Subject: Collin County Healthcare Facility, Parking Garage, and Medical Examiners
Revised PCO No. 068; RFI #255 Lower-Level PG Wall Access Opening.

Issue No. 068 - RFI #255 Lower Level PG Wall Access Opening **Amount**

RFI #255: PG - Lower-Level Wall Access Opening to Exhaust Fans Behind CMU Partition

PG-A0.30

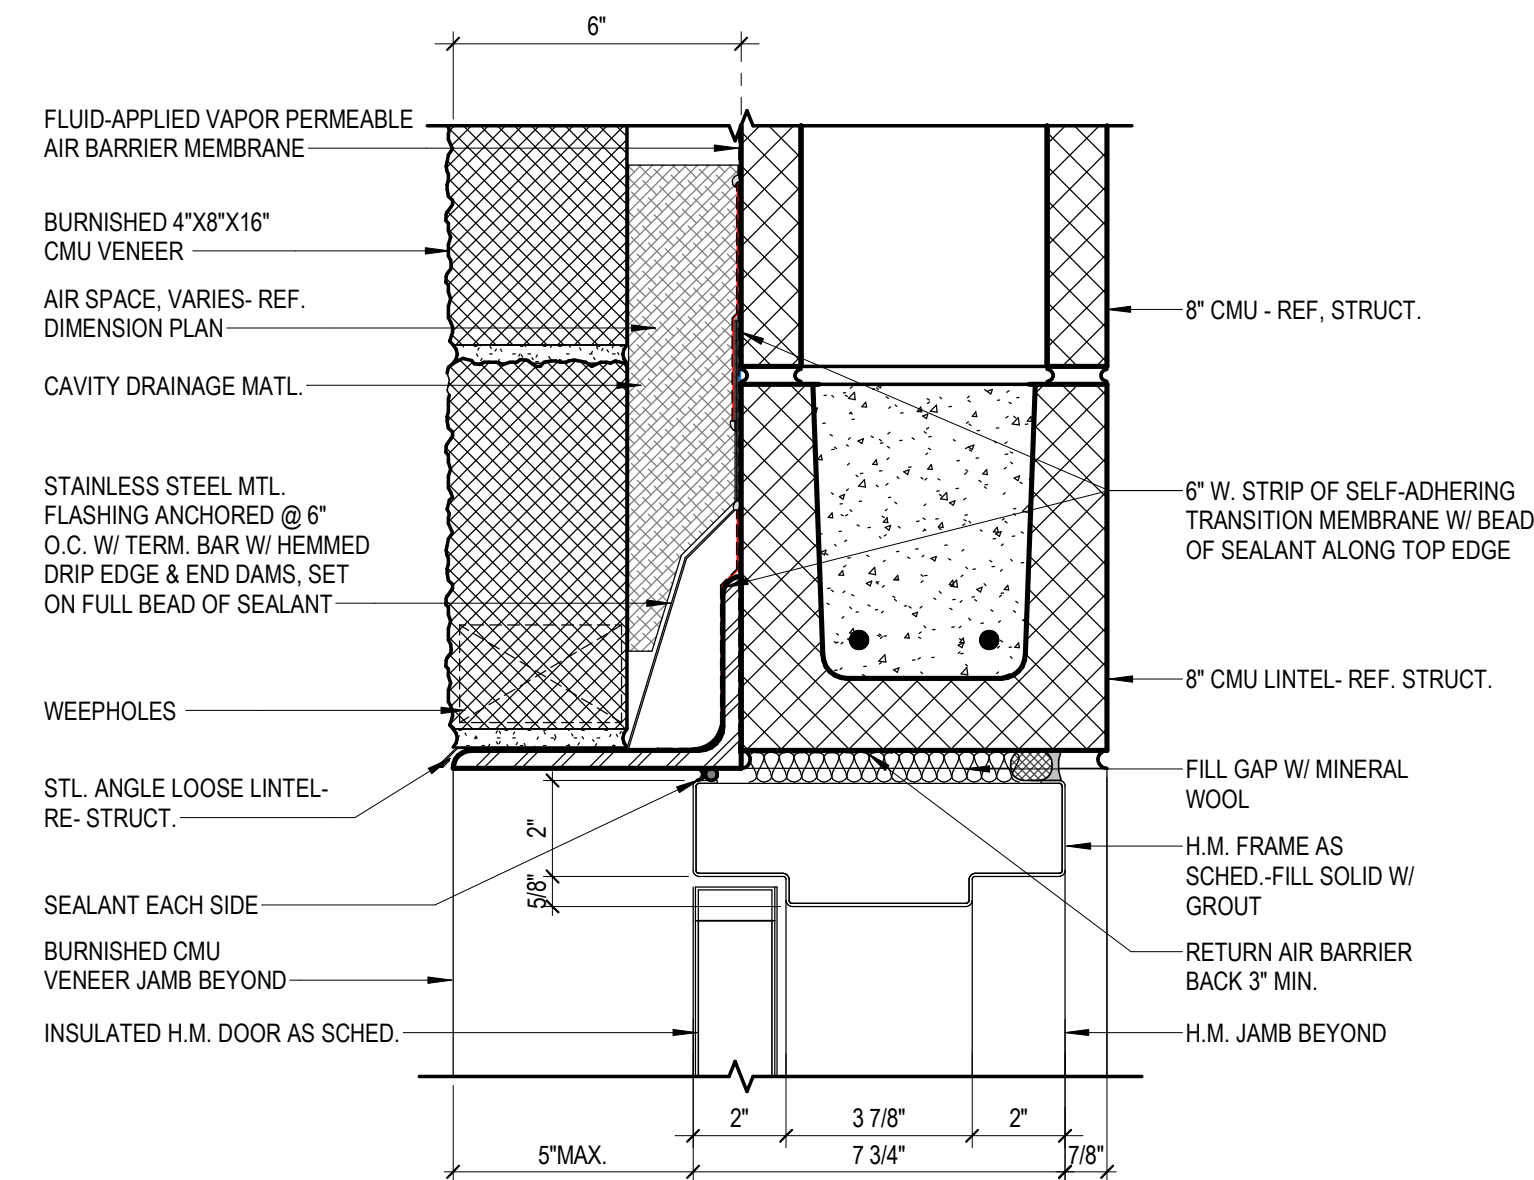
- **Updated lower-level HVAC equipment access adjacent to Storage L05 per updated RFI 255 response:**
 - **Includes additional material and labor hollow metal door, frame, and hardware.**
 - **Includes additional electrical material and labor for added light fixtures and new and modified associated circuits and breakers per RFI response.**
- ***This PCO will be an add in the amount of \$7,209.***

PLEASE SEE ATTACHED UPDATED SHEETS PG-A0.30 - DOOR SCHEDULE & PG-A2.01 - LOWER LEVEL FLOOR PLAN, FOR NEW DOOR LOCATION TO THE MECHANICAL SPACE.

LOWER LEVEL	L01F	L01	PARKING LOWER LEVEL	3'-0"	8'-0"	13/4"	HM	F	PT	HM	003	PT-22	6"	7A/0.30	6A/0.30			45 MIN 33.0			
LOWER LEVEL	L01G	L01	PARKING LOWER LEVEL	6'-0"	7'-0"	13/4"	HM	F	PT	HM	001	PT-22	6"	7A/0.30	6A/0.30			30 MIN 34.5			
LOWER LEVEL	L05F	L05	STORAGE	3'-0"	4'-4 3/4"	13/4"	HM	F	PT	HM	003	PT-22	6"	9A/0.30	8A/0.30			33.0		MECHANICAL USE ACCESS ONLY	
LOWER LEVEL	L06	L06	FIRE RISER ROOM	8'-0"	8'-0"	13/4"	ALUM	F	PT	HM	003	PT-22	6"	9A/0.30	8A/0.30			31.0			
LOWER LEVEL	L07	L07	DOMESTIC WATER	3'-0"	8'-0"	13/4"	HM	F	PT	HM	003	PT-22	6"	9A/0.30	8A/0.30			31.0			
LEVEL 1	100A	100	PARKING LEVEL 1	25'-0"	8'-8"	13/4"	ALUM	HC	PT	HM	00H.C	HM	6"						32.0		OVERHEAD COILING SECURITY GRILLE
LEVEL 1	100B	100	PARKING LEVEL 1	3'-0"	8'-0"	13/4"	HM	F	PT	HM	003	PT-21	6"	9A/0.30	8A/0.30			30.5		PEDESTRIAN METAL GATE W/ 2" JAMB	
LEVEL 1	100C	100	PARKING LEVEL 1	3'-0"	8'-0"	13/4"	HM	F	PT	HM	003	PT-21	6"	11A/0.30	10A/0.30			30.5		PEDESTRIAN METAL GATE W/ 2" JAMB

FLOOR PLAN - LOWER LEVEL - ELECTRICAL 1/16" = 1'-0" 1

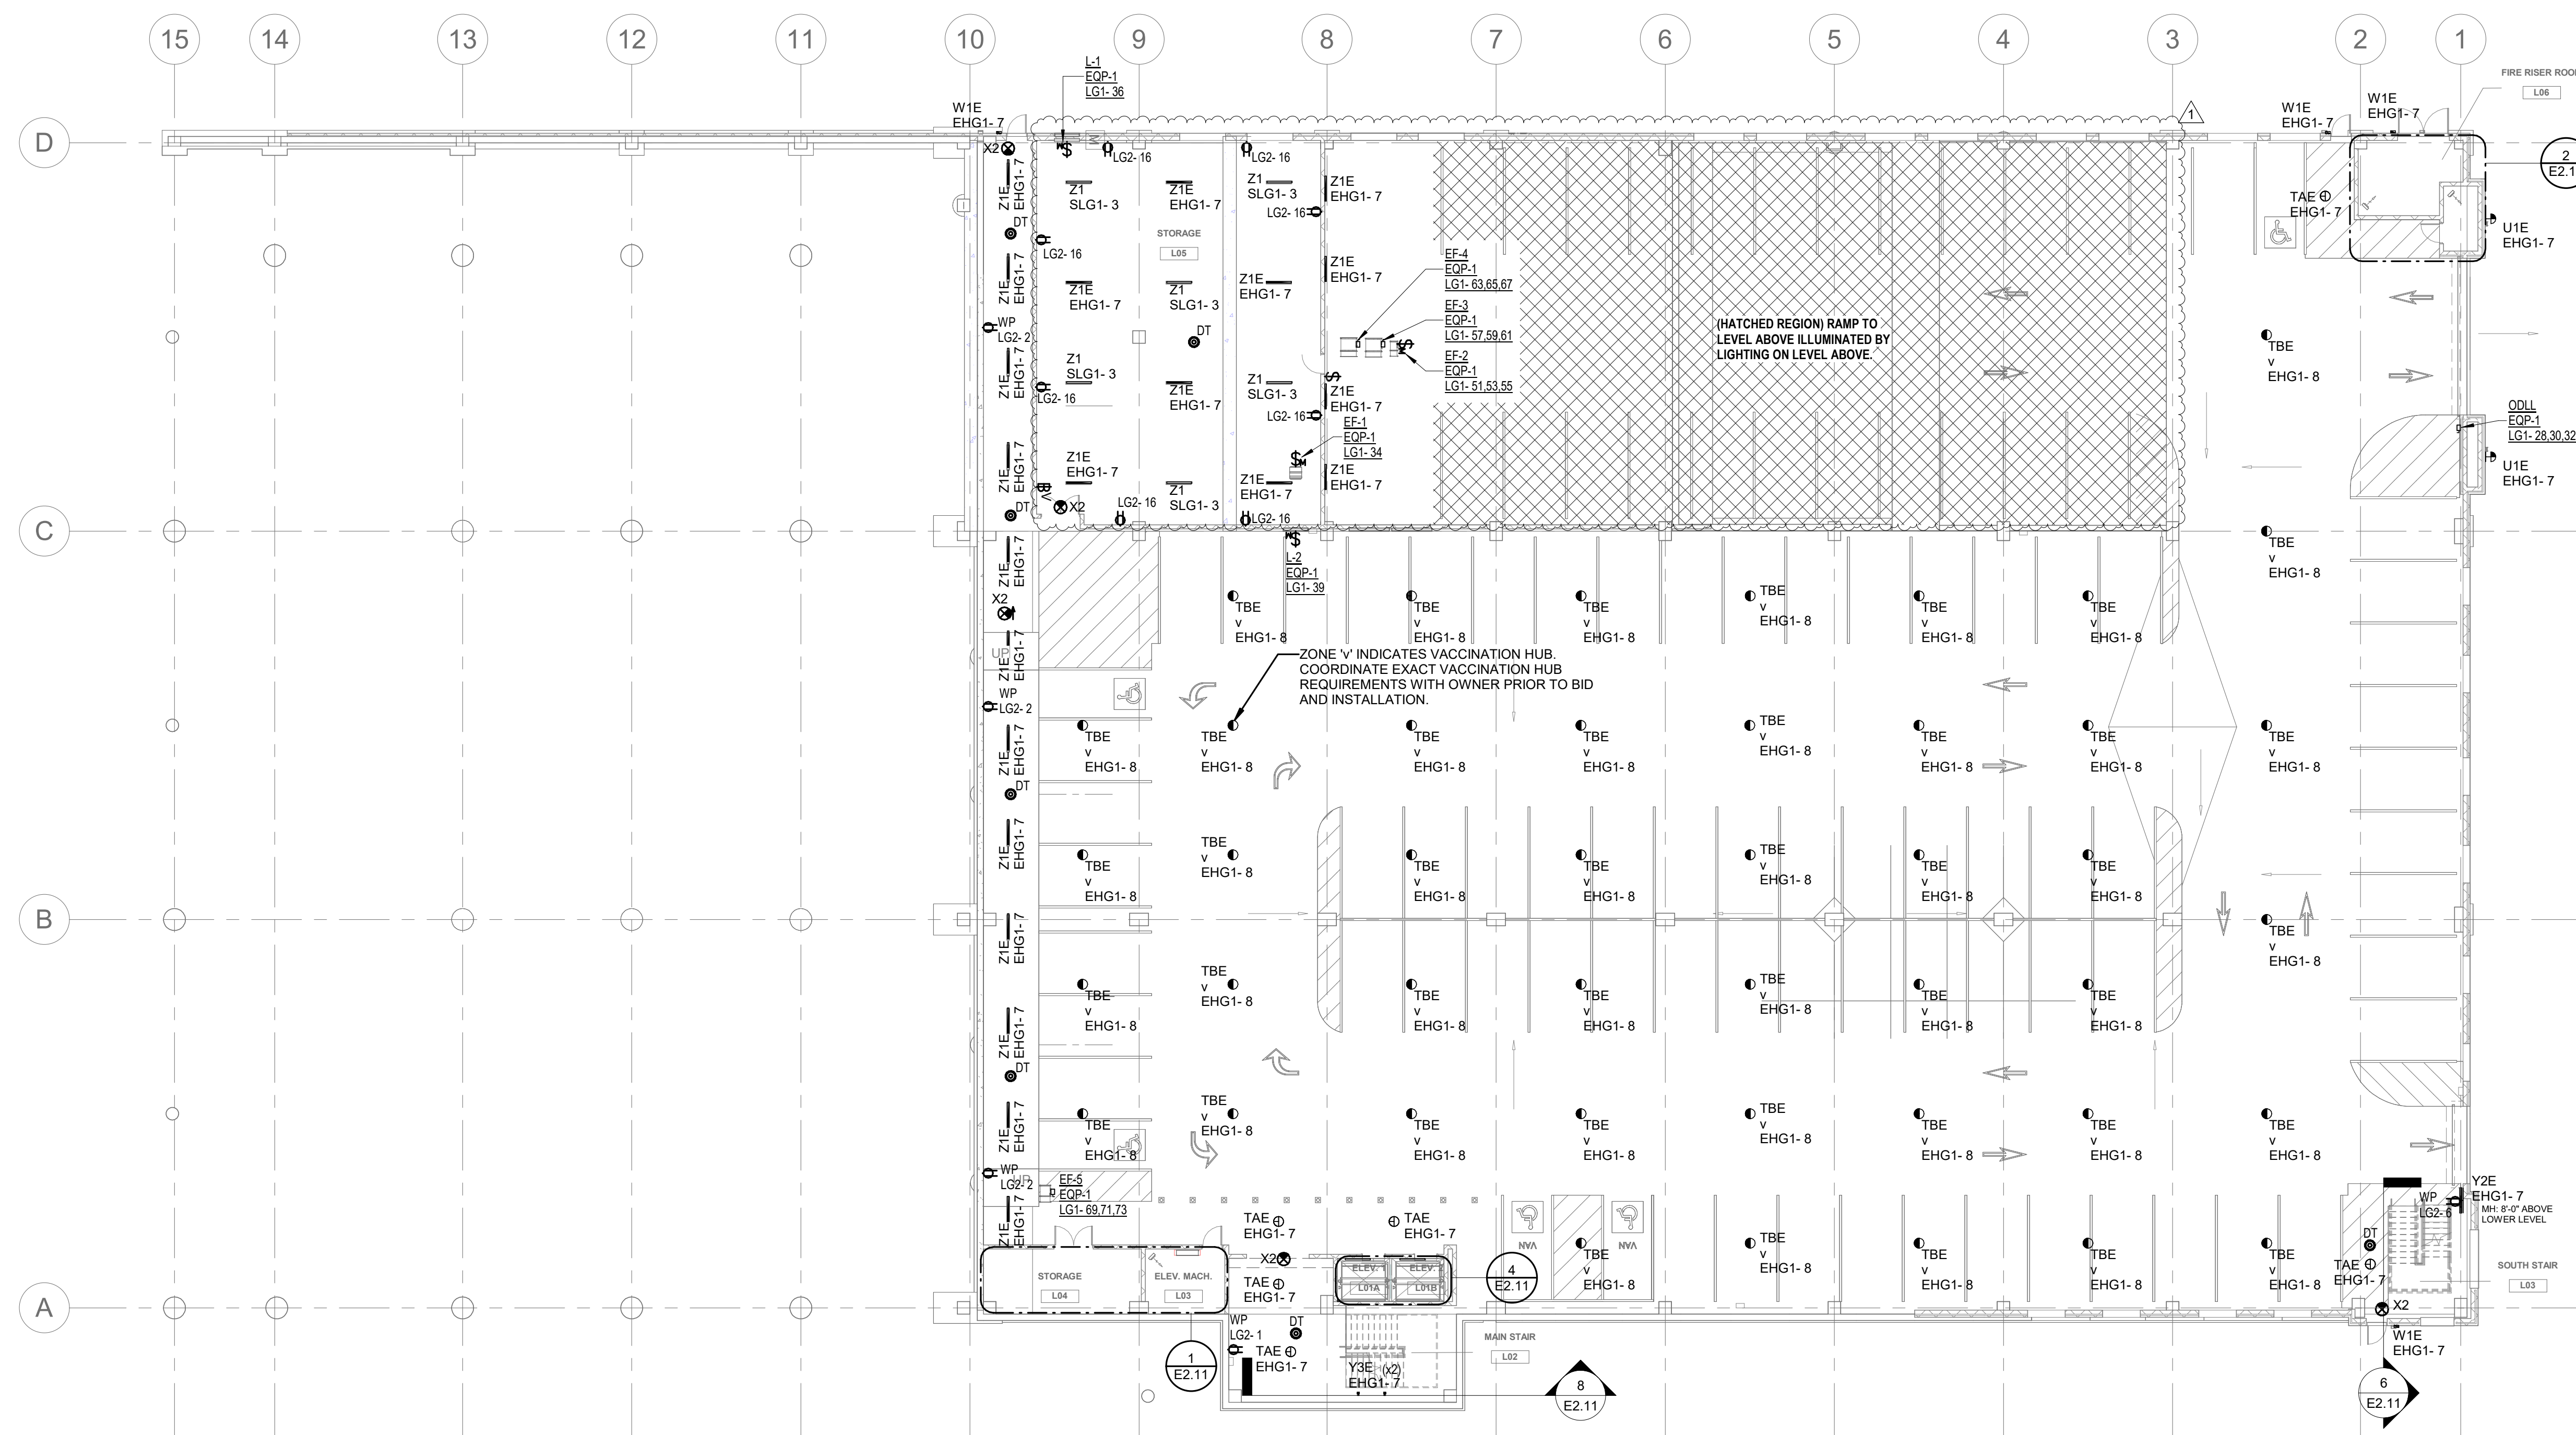
Please additionally clarify if there is any required lighting to be installed in this area.

1. PG-E2.01 Add four type Z1E fixtures, change six Z1 fixtures to Z1E, add one X2 Exit fixture, add one DT sensor, add one surface mounted light switch and delete three TBE fixtures.
2. PG-E2.02 Move light fixtures from circuit #9 to circuit #11 in panel EHG1.
3. PG-E2-03 Move light fixtures from circuit #11 to circuit #13 in panel EHG1
4. PG-E3.00 Add (6) 60A/2 pole breakers to panel LG1, change 100A/3 pole breaker in panel EHG1 to 150A/3 pole breaker and remove (10) 20A/1.

REF: PG-A2.01

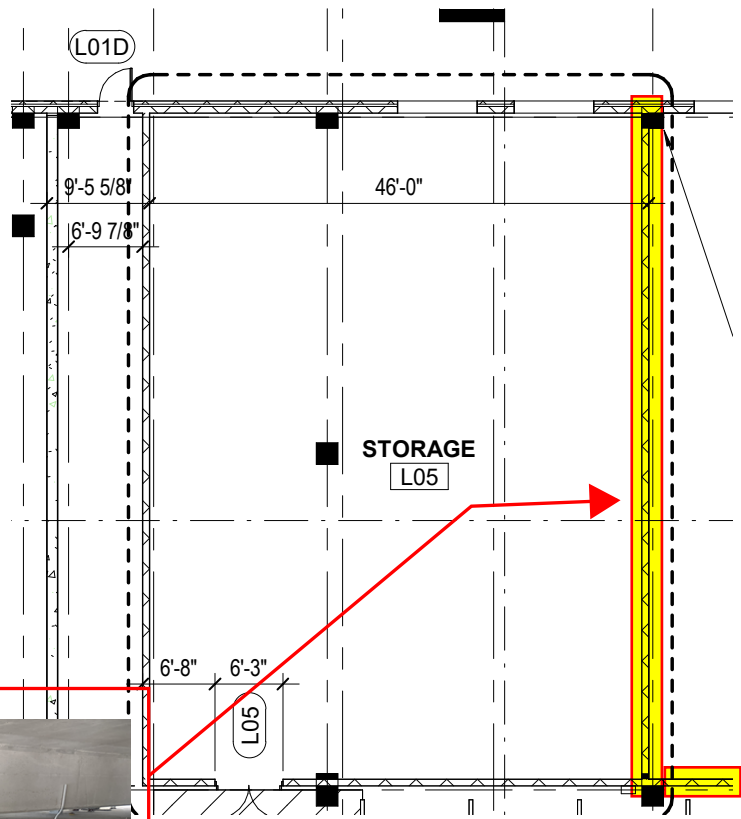
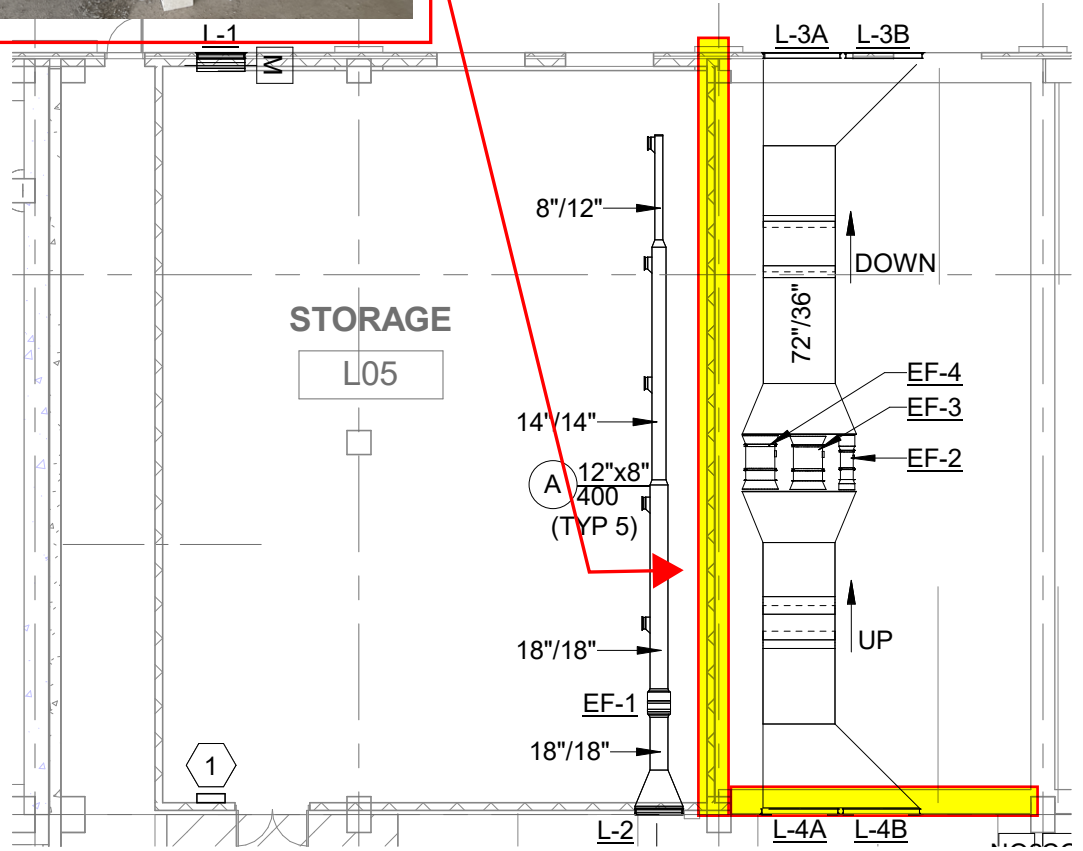
There is not currently a scheduled opening located on the CMU wall shown and highlighted in the PG lower level.

Located underneath the PG lower level ramp section and adjacent to the storage room are scheduled exhaust fans. Those mechanical units will require some sort of opening access to allow for service, maintenance, or replacement. Please advise/specify the type and size of this wall access needed.

Height of opening 4'-7"

This storage area is closed to the public and restrict to access by authorized personnel. That being the case, I think an opening in the wall without a door is acceptable. A dedicated in-line toggle switch should be provided in this space, serving the fixtures that are added to this space. It should be viewed like a crawlspace. We will provide an updated sheet showing a gap in the wall and updated lighting fixtures.

REF: PG-M2.01

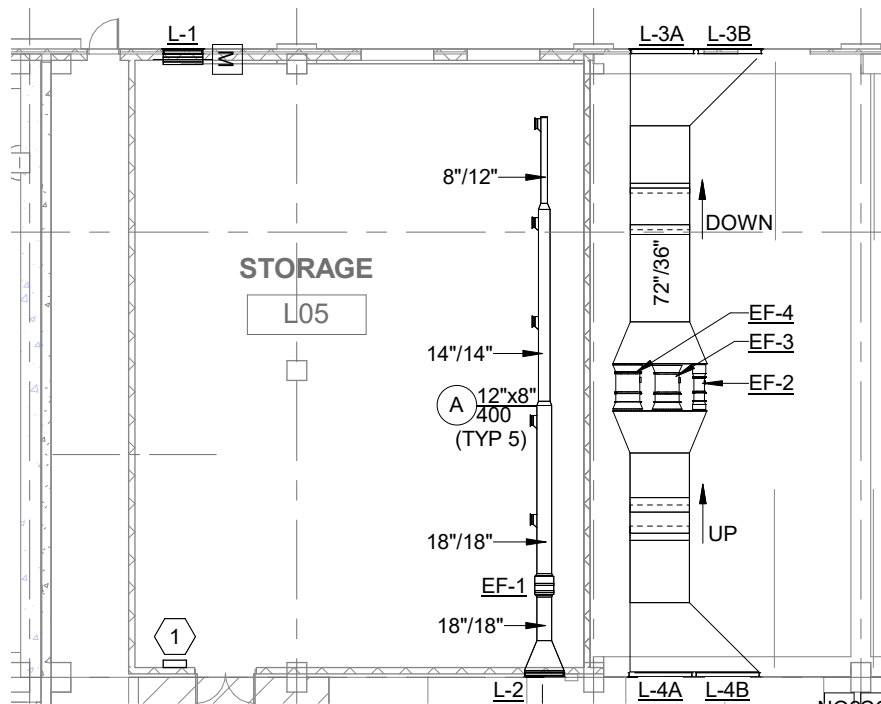
Lastly, the scheduled CMU partition will seal this area off from ventilation and lighting upon completion. Will there be any signage required to be installed at any wall access location cautioning others of a confined space?

Exhaust Fans (EF) EF-2, EF-3, & EF-4 shown here

REFER TO ELECTRICAL SHEETS FOR THE UPDATED LIGHT FIXTURE PLAN FOR THE MECHANICAL SPACE.
